UNITED STATES PATENT AND TRADEMARK OFFICE

APPLICATION NO.	FILING DATE	FIRST NAMED INVENTOR	ATTORNEY DOCKET NO.	CONFIRMATION NO.
09/864,581	05/24/2001	David W. Beddome	90099012	2137
7590 12/12/2003 Felix L. Fischer Honeywell International Inc. Suite 200 23326 Hawthorne Boulevard Torrance, CA 90505			EXAMINER DUONG, THO V	
			ART UNIT 3743	PAPER NUMBER 17
DATE MAILED: 12/12/2003

Office Action Summary

Figure A: The modified figure correspondes to figure 1 with claimed limitations shown

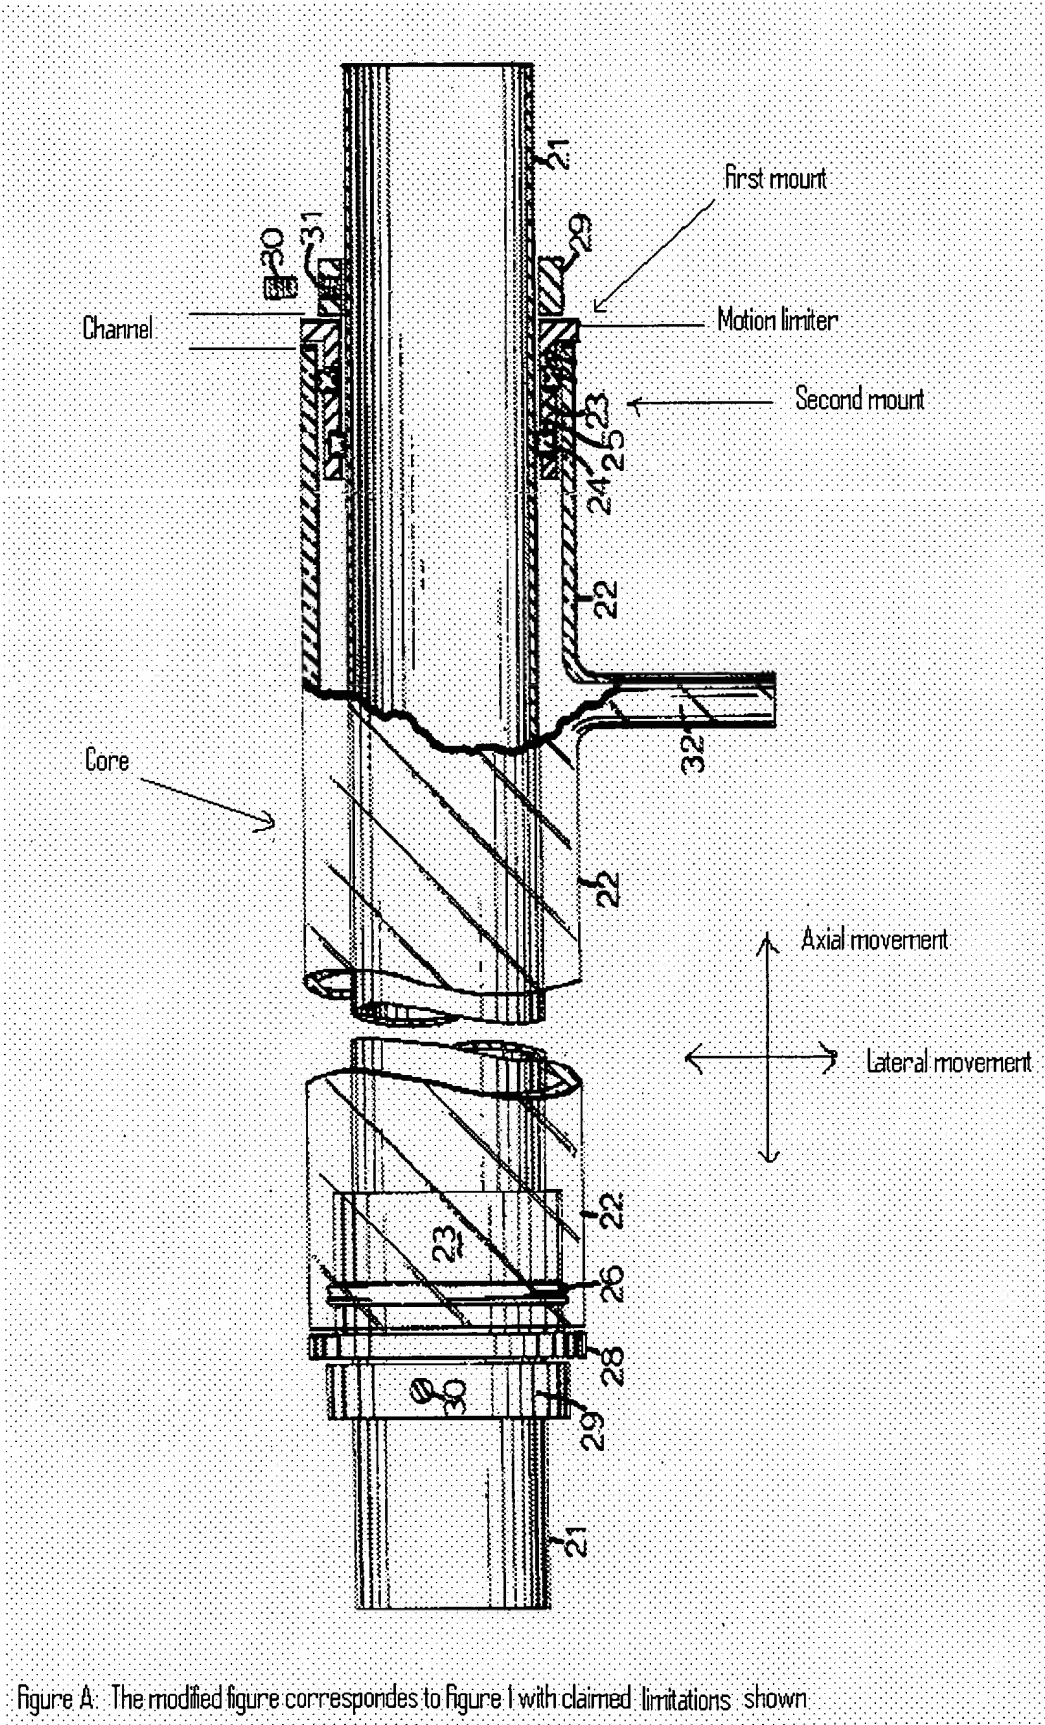
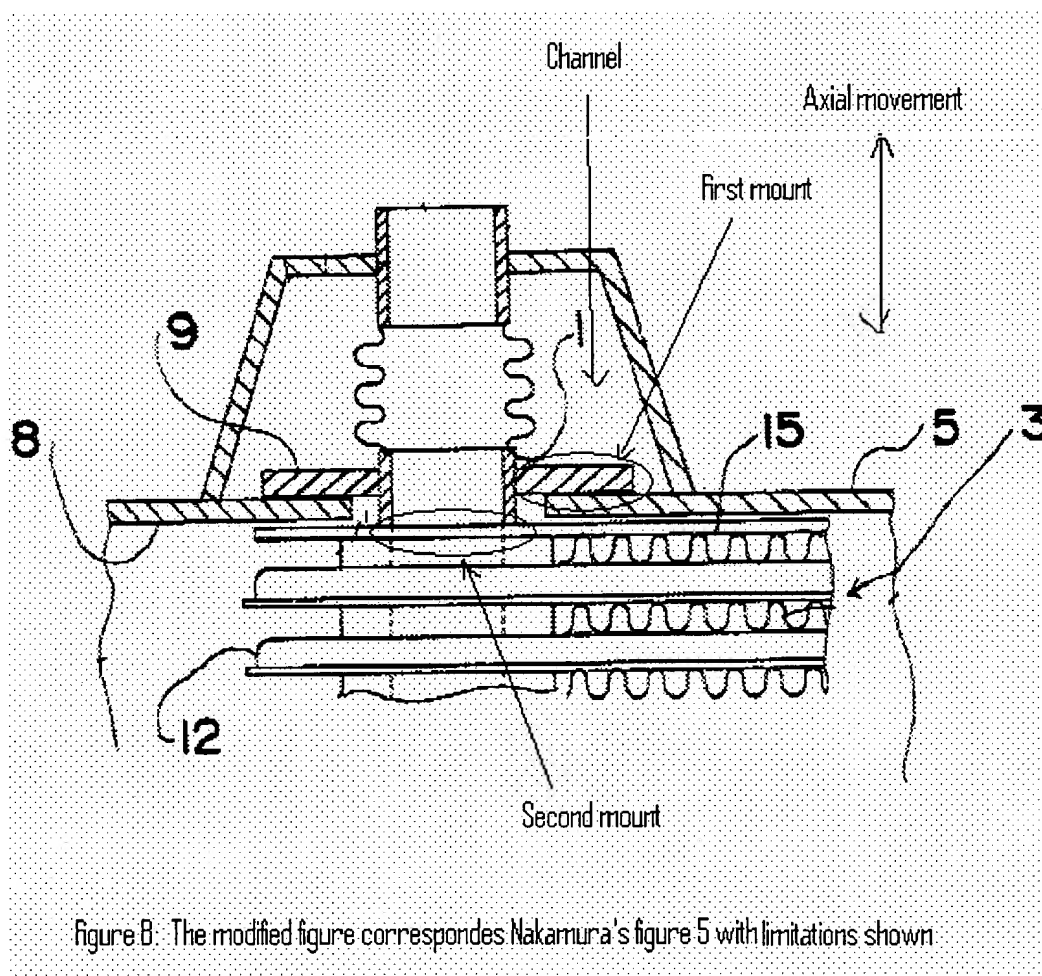
Claims 27,28,30,31,32,34,45 and 46 are rejected under 35 U.S.C. 102(b) as being anticipated by Mather et al. (US 4,151,828). Mather discloses (figures 1-3 and column 5, lines 58-68) a heat exchanger comprising a core (22) having a heat exchange portion (inside of the

core); a tube (21) has a longitudinal axis including a motion limiter (28) extending radially therefrom to limit upward or downward axial motion of the tube, wherein at least a portion of the tube extends into the core (22) and wherein the tube (21) is positioned at least adjacent to the heat exchange portion of the core; a load bearing member (29) positioned adjacent to the core (22); and a first mount positioned between the tube (21) and the load bearing member (29), so that the load bearing member can receive loads from the tube via the motion limiter (28) when the tube is expanded; the first mount comprises a channel defined by the load bearing member (29) and the core (22), wherein the motion limiter (28) is received by the channel such that the movement of the motion limiter is restrained by the channel and since the motion limiter is freely moving within the channel, the first mount is adjustable to expand separately from the load bearing member; the heat exchanger further comprising a manifold (33); and a second mount (23) positioned between the tube (21) and the core (22). See Figure A (page 6) for clarity of the anticipation. As regarding claims 27, 31 and 34, it has been held that the recitation an element is “capable of” performing a function is not positive limitation but only requires the ability to so perform. It does not constitute a limitation in any patentable sense. In re Hutchison, 69 USPQ 138. In this instant application, Mathers’ tube has ability to contact with the core to transfer load between the tube (21) and the core, to provide support to the core (22), to increase stiffness of the core; the second mount (23) has ability to transfer loads between the tube and the core and to restrain lateral movement of the tube; and the first mount has ability to restrain axial movement of the tube. As regarding functional recitations in 45-46, the first mount shown in reference Mather is structurally the same as the first mount as claimed. Therefore, the claimed function performing by the claimed first mount is inherently from the first mount of Mather. Furthermore,

MPEP 2114 (R-1) states that while features of an apparatus may be recited either structurally or functionally, claims directed to an apparatus must be distinguished from the prior art in terms of structure rather than function. In re Schreiber, 128 F.3d 1473, 1477-78, 44 USPQ2d 1429, 1431-32 (Fed. Cir. 1997). As regarding claim 30, it has been held that a recitation with respect to the manner in which a claimed apparatus is intended to be employed does not differentiate the claimed apparatus from a prior art apparatus satisfying the claimed structural limitation. Ex parte Masham, 2 USPQ2d 1647 (1987). In this instant application, the intended use recitation of “for passing a fluid from and to the core” does not differentiate claimed manifold from Mather’s manifold (30) satisfying the claimed structural limitations.
